Application No.	Applicant(s)			
Office Action Summary		10/518,334	KISMIR ET AL.			
		Examiner	Art Unit			
		Eric Culbreth	3616			
	The MAILING DATE of this communication app		with the correspondence address			
Period fo	• •		MONTH(O) OF THEFTY (20) PAYO			
WHIC - Exte after - If NC - Failt Any	ORTENED STATUTORY PERIOD FOR REPL' CHEVER IS LONGER, FROM THE MAILING Donsions of time may be available under the provisions of 37 CFR 1.1 SIX (6) MONTHS from the mailing date of this communication. Operiod for reply is specified above, the maximum statutory period was the reply within the set or extended period for reply will, by statute reply received by the Office later than three months after the mailing ed patent term adjustment. See 37 CFR 1.704(b).	ATE OF THIS COMMUN 36(a). In no event, however, may will apply and will expire SIX (6) Minus cause the application to become	NICATION. a reply be timely filed ONTHS from the mailing date of this communication. ABANDONED (35 U.S.C. § 133).

Continuation of Attachment(s) 6). Other: Replacement sheets (not approved).

DETAILED ACTION

ec /Eric Culbreth/ Primary Examiner, Art Unit 3616 Approved EC 1/12108 In re Appln. of: Altay Kismir et al For: Alr-Bag Atturney Docket No.: 12400-28 REPLACEMENT SHEET 1 4 36 ∞ (Prior Art) Q. \mathfrak{A} **ω** 9 88 28 0 C 0 25 20 18 21 22 88 21 20 18 23 24 82

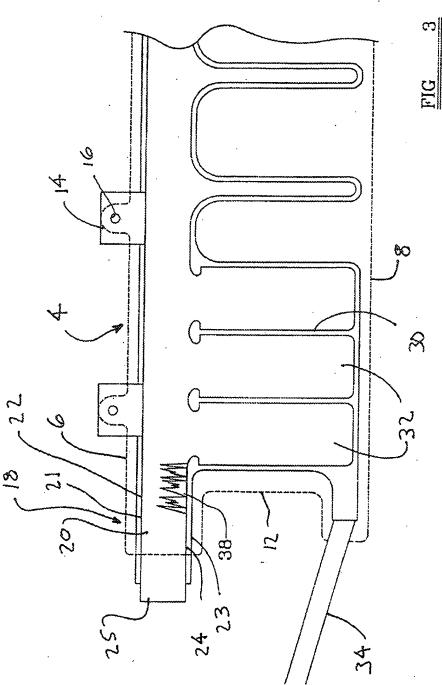
1. The drawings were received on 10/26/08. These drawings are not approved because the illustration of apertures 46 in Figure 4 is new matter (size, shape).

It is not necessary to resubmit the replacement sheets. Rather, if paragraph 46 were amended to state that the apertures at 46 are "schematic", that is, for illustrative purposes only.

Not Capproved EC V12-108
